ITEM NO	NEXT ASSEMBLY	REQD
 THIS DRAWING IS THE PROPERTY OF <b>ARGONNE NATIONAL LABORATORY</b>		
TITLE		
Modifications to VERITAS Foundation		
SCALE	SHEET OF	DRAWING NUMBER
		CTA-10-7-1
		REV

BUILDING NAME	
ADDRESS	670 MT. HOPKINS ROAD AMADO, ARIZONA
PROJECT TITLE	VERITAS PROTOTYPE FDN.
USED PROJECT NUMBER	0382102
A/E PROJECT NUMBER	M3 PN02260

DRAWING TITLE	FOUNDATION PLAN STRUCTURAL DETAILS		
DRAWING TYPE	STRUCTURAL		
WORKING STAFF	DN	AC	DN
DESIGNED BY		DRAWN BY	CHECKED BY

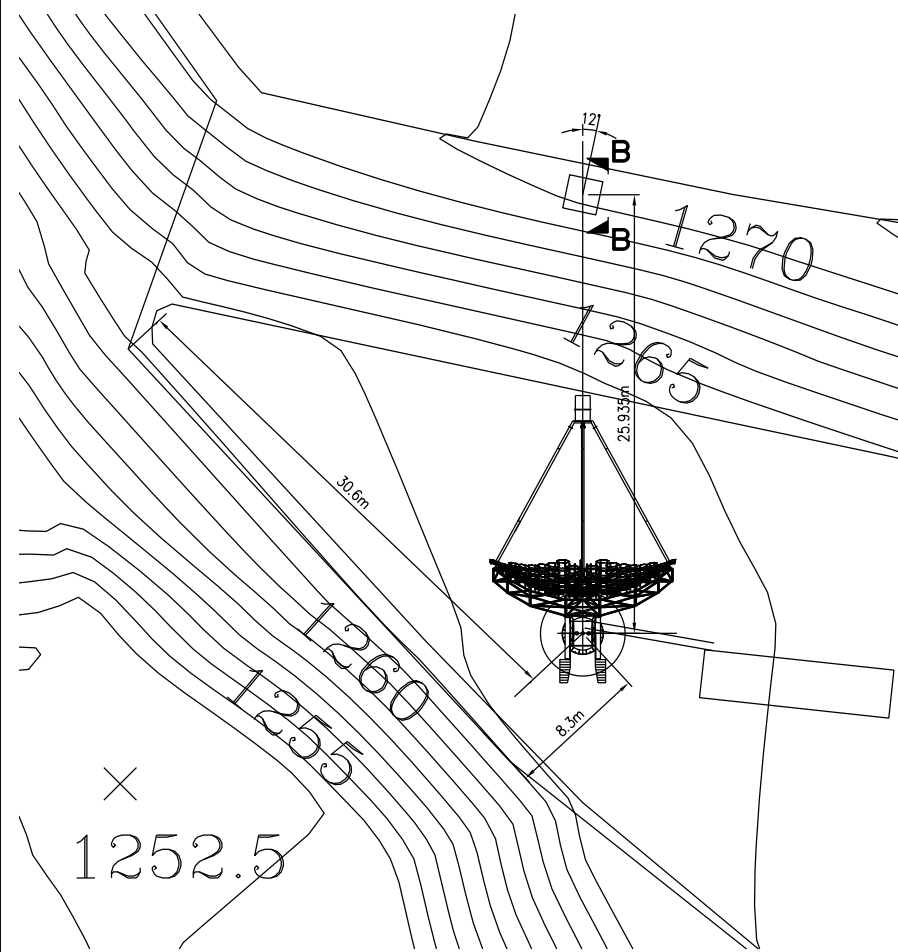
Revise Foundation design (see 02260s1 comments) to accommodate slope? Also do we need to ground the rebar and add additional grounding rods using the old spec?

**FOUNDATION PLAN**  
SCALE: 1 : 30

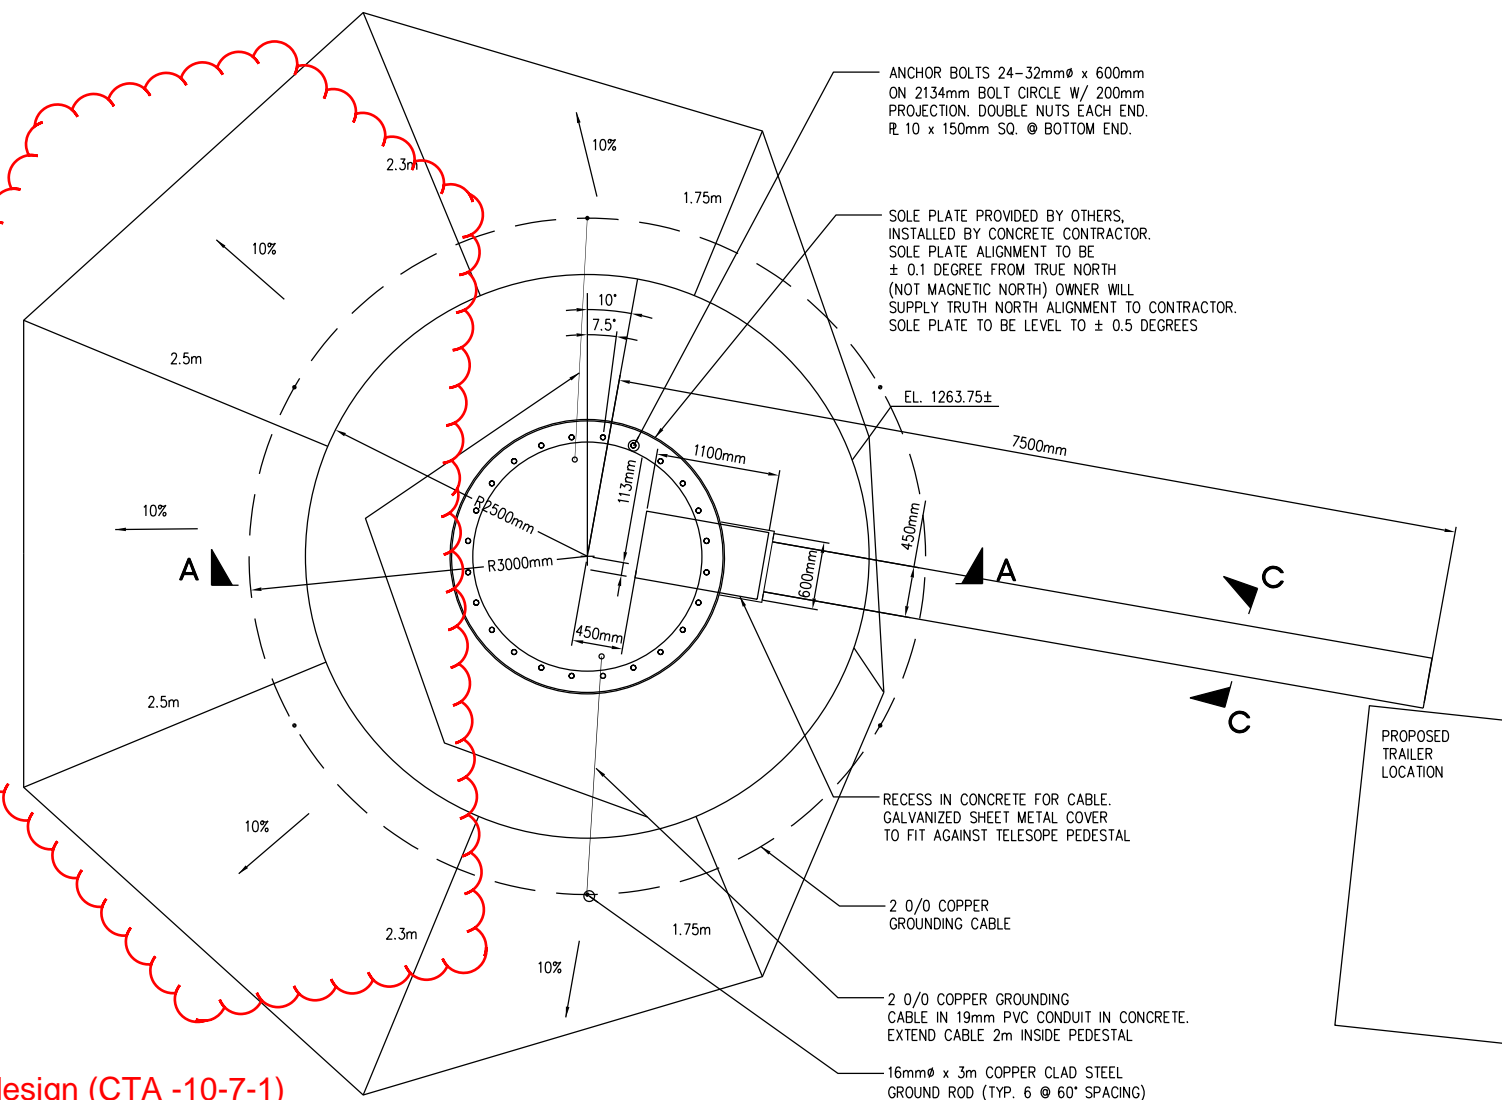
Revise Foundation design (CTA -10-7-1) to accommodate slope? Do we we need to ground the new rebar using this spec?

**\*\*GROUNDING CABLE NOTE:**  
ALL CONNECTIONS SHALL BE CADWELDED.  
Do we we need to ground the new rebar using this spec? Repull grounding cable to base of pedestal?

**SECTION B-B**  
SCALE: 1 : 20

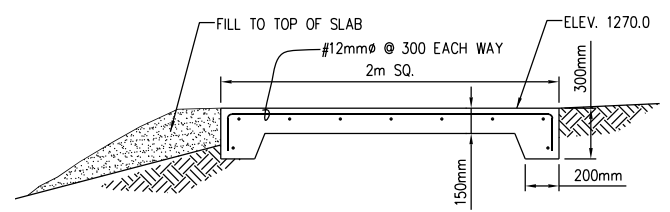
Revise Foundation design (CTA -10-7-1) to accommodate slope?

**SECTION C-C**  
SCALE: 1 : 20

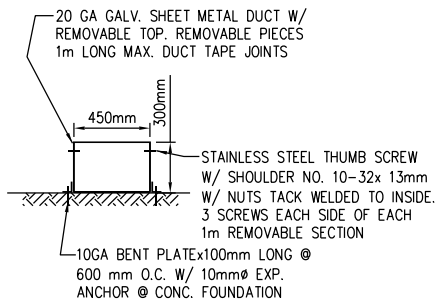
There is a possibility that the grounding system may be disturbed or damaged while doing the excavation, etc.
